# **MEMO**

Review of Water Right Application G-18540

August 9, 2018

## **Groundwater Application Review Summary Form**

Figure 2. Well Location Map

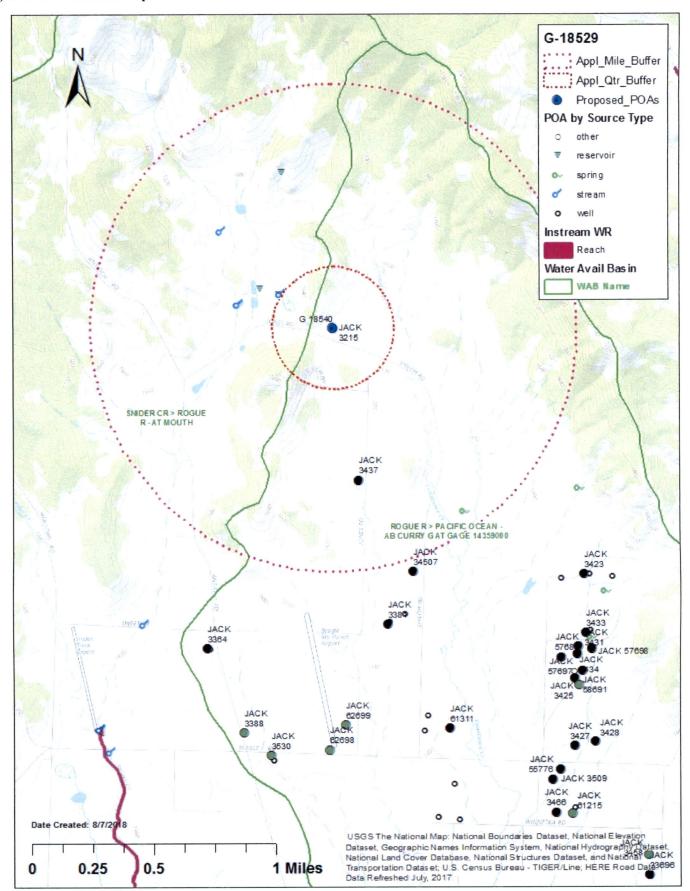
Basis for aquifer hydraulic connection evaluation: Observed SWL elevations are higher than perennial stream elevations, indicating that groundwater flows towards and discharges to surface water. The applicant's well is located approximately 500 feet from a low saddle on the divide between Snider and Constance Creeks. Pumping affects would likely intercept subsurface flow in the Snider Creek basin. Thus the applicant's well is assumed to be hydraulically connected to Snider Creek.

Figure 3. Water-Level Trends in Nearby Wells

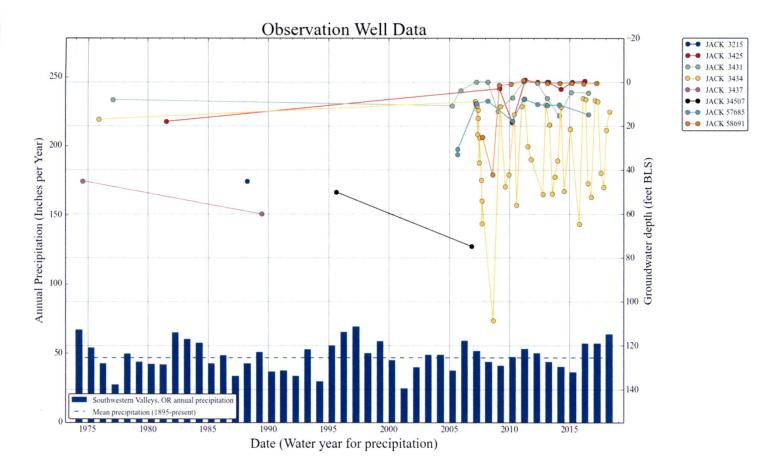
Cliffs Formation. Wells in this aquifer system typically produce less than 50 gpm. There are no current OWRD observation well data within 1 mile of the proposed POA so aquifer over-appropriation cannot be determined. However, a cluster of observation wells accessing the Payne Cliffs Formation 1-2 miles to the south shows relatively stable water levels over the previous 10-20 years (see Figure 3).  The closest valid POA is >3300 feet from the applicant's well. Adjacent taxlot density (as a proxy for well development) is moderate and the Department is unaware of historic interference problems. Similarly, the above mentioned cluster of wells has a higher development density and water levels do not show systemic decline. Considering these lines of evidence, it is		issuance of the permit until evidence of well reconstruction is filed with the Department and approved by the Groundwater Section.  Describe injury —as related to water availability—that is likely to occur without well reconstruction (interference w/

moderate and the Department is unaware of historic interference problems. Similarly, the above mentioned cluster of wells has a higher development density and water levels do not show systemic decline. Considering these lines of evidence, it is	Clif well obse	If s Formation. Wells in this aquifer system typically produce less than 50 gpm. There are no current OWRD observation and data within 1 mile of the proposed POA so aquifer over-appropriation cannot be determined. However, a cluster of ervation wells accessing the Payne Cliffs Formation 1-2 miles to the south shows relatively stable water levels over the
	moc has	derate and the Department is unaware of historic interference problems. Similarly, the above mentioned cluster of wells a higher development density and water levels do not show systemic decline. Considering these lines of evidence, it is
	_
